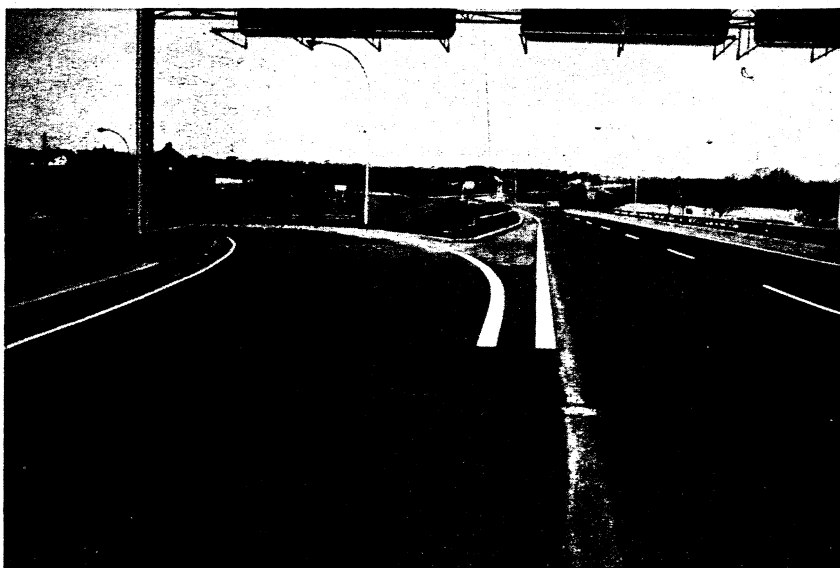
This gore has had its share of skid marks, and again in this location you have guardrails starting here and guardrails starting here [indicating], which are hazards of themselves and desirably should be down to ground level and anchored.

This is a section of gore. This is just off the project, but again a place where a guardrail has been applied similar to the last picture, and it has been struck as you can see.

That is not too good delineation there, nor too good protection of the area.
